# Sun SPARC® Enterprise M8000/M9000 Servers Product Notes

For XCP Version 1060

Part No. 820-3611-10  
November 2007, Revision A

**FIGURE 1** Sun SPARC Enterprise M8000 Server + Power Cabinet Bottom View

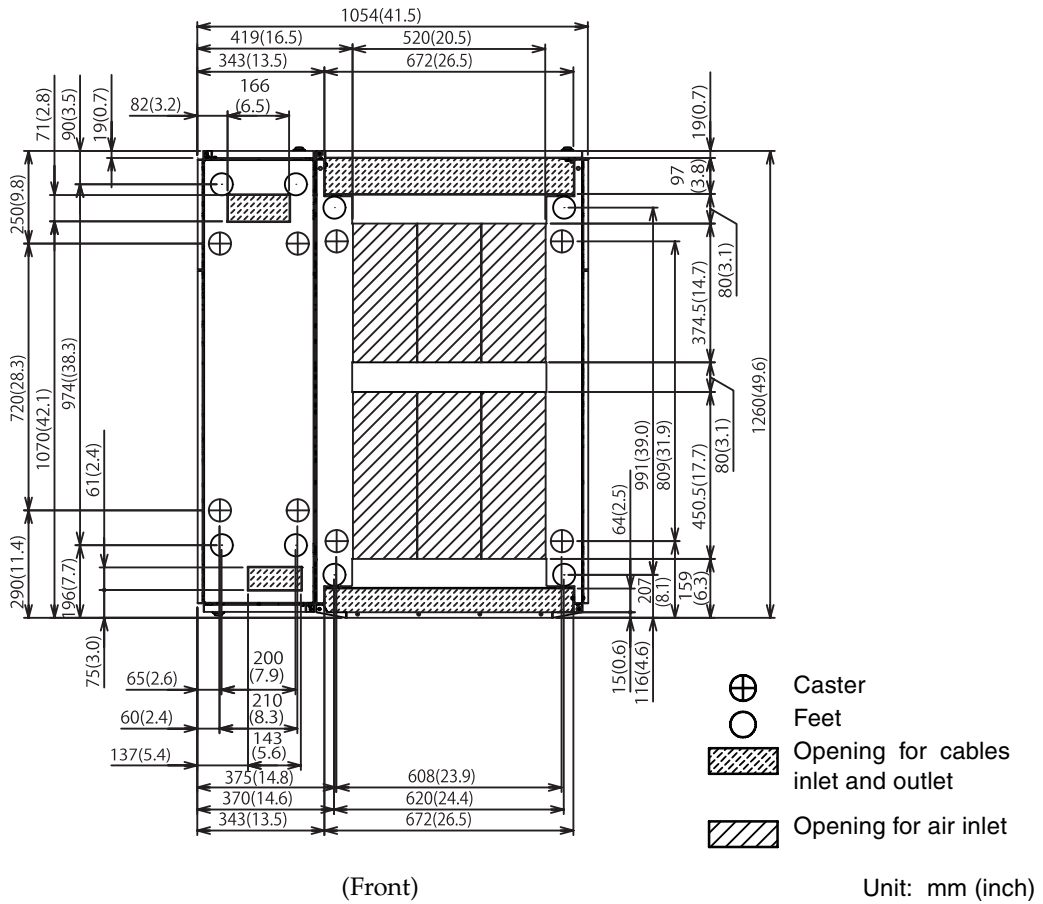
The following figures are a correction to the description in Section 1.2.2.2, "Bottom View of the Components".

**FIGURE 1** shows the Sun SPARC Enterprise M8000 Server + Power Cabinet Bottom View.

FIGURE 2 Sun SPARC Enterprise M9000 Server (Base Cabinet) + Power Cabinet Bottom View

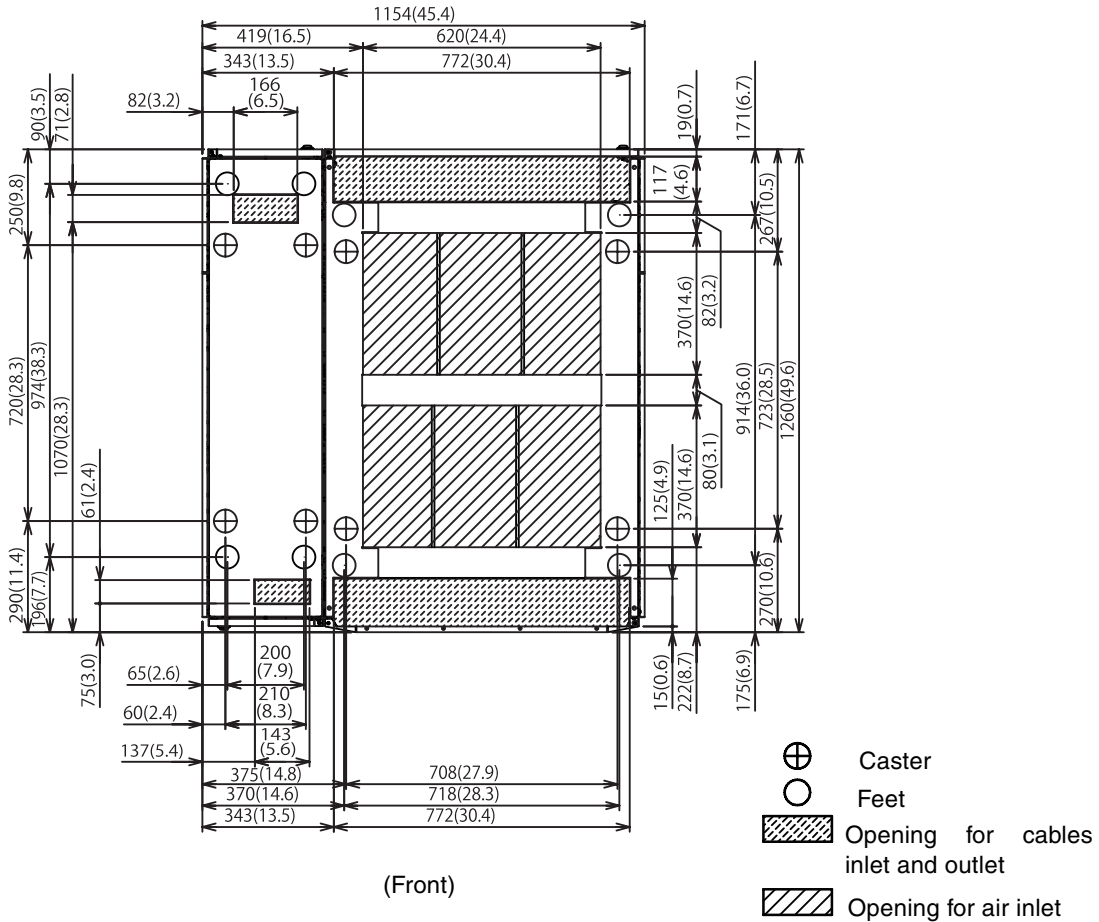
**FIGURE 2** shows the Sun SPARC Enterprise M9000 Server (Base Cabinet) + Power Cabinet Bottom View.
